TRAFFIC LOOP LAYOUT SHEET #2

PROJECT NAME: WALLINGFORD - RUTLAND TOWN
PROJECT NUMBER: NH 2408(1)S

PLOT DATE: \$DATE\$
DRAWN BY: C.A.K.
CHECKED BY: D.E.G.
SHEET 38 OF 80

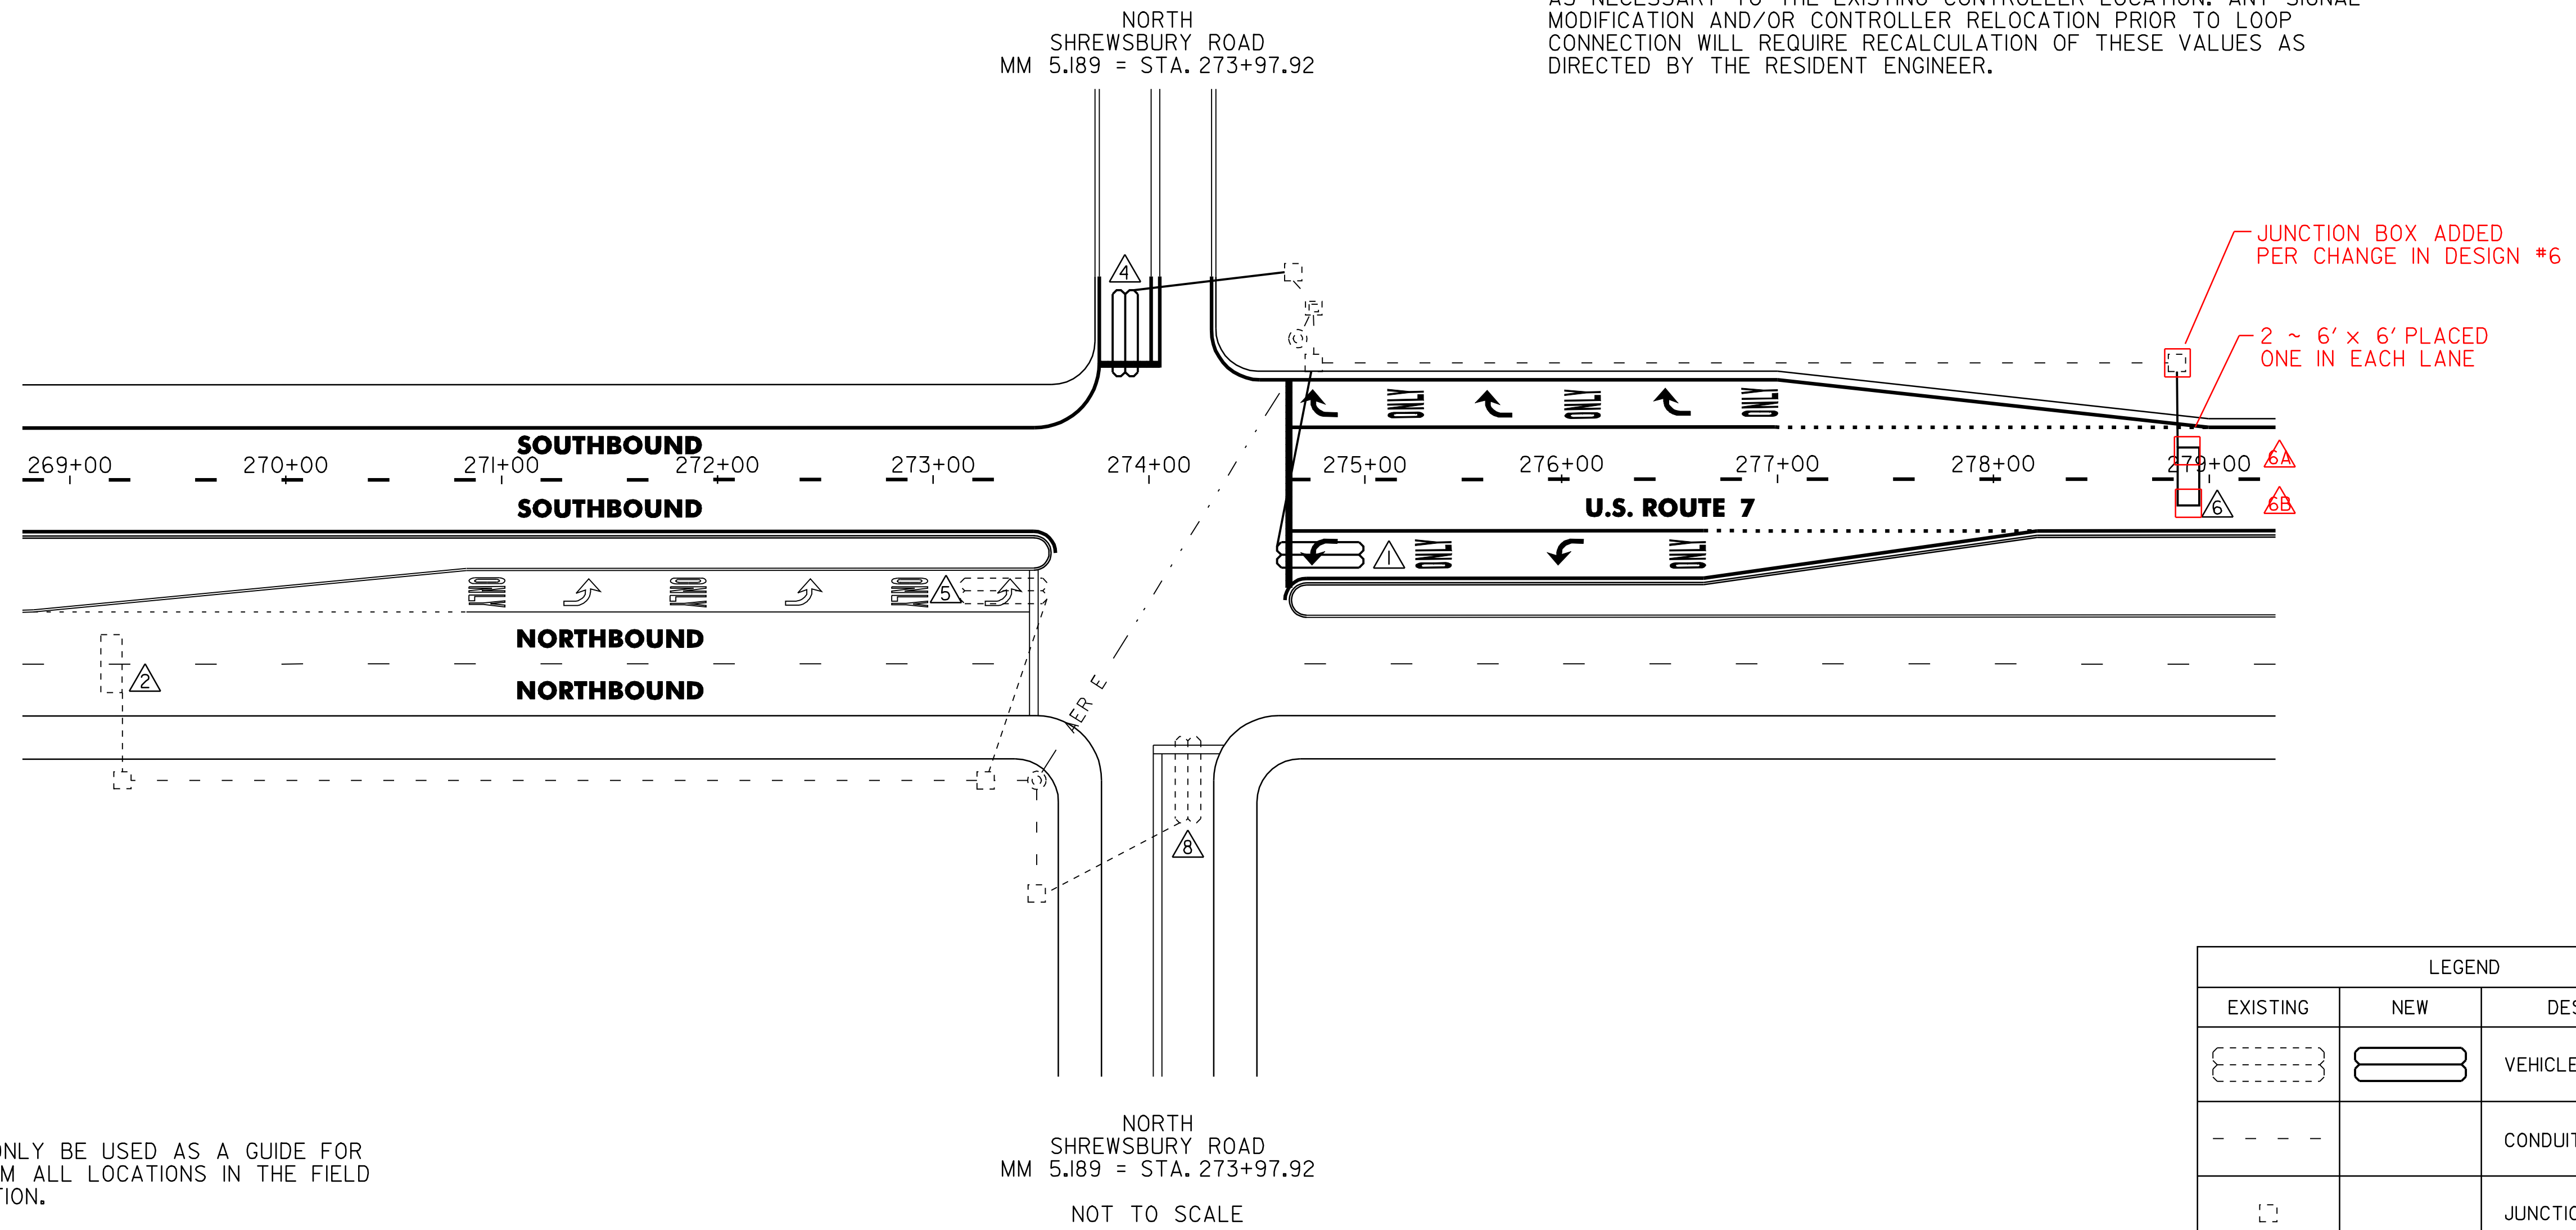
- LOOP 1 - 172 FT 173.5 FT
- LOOP 4 - 148 FT
- ~~LOOP 6 - 72 FT~~
- LOOP 6A - 40 FT
- LOOP 6B - 49 FT

- SB TL △6A 6' x 6'
- SB PL △6B 6' x 6'
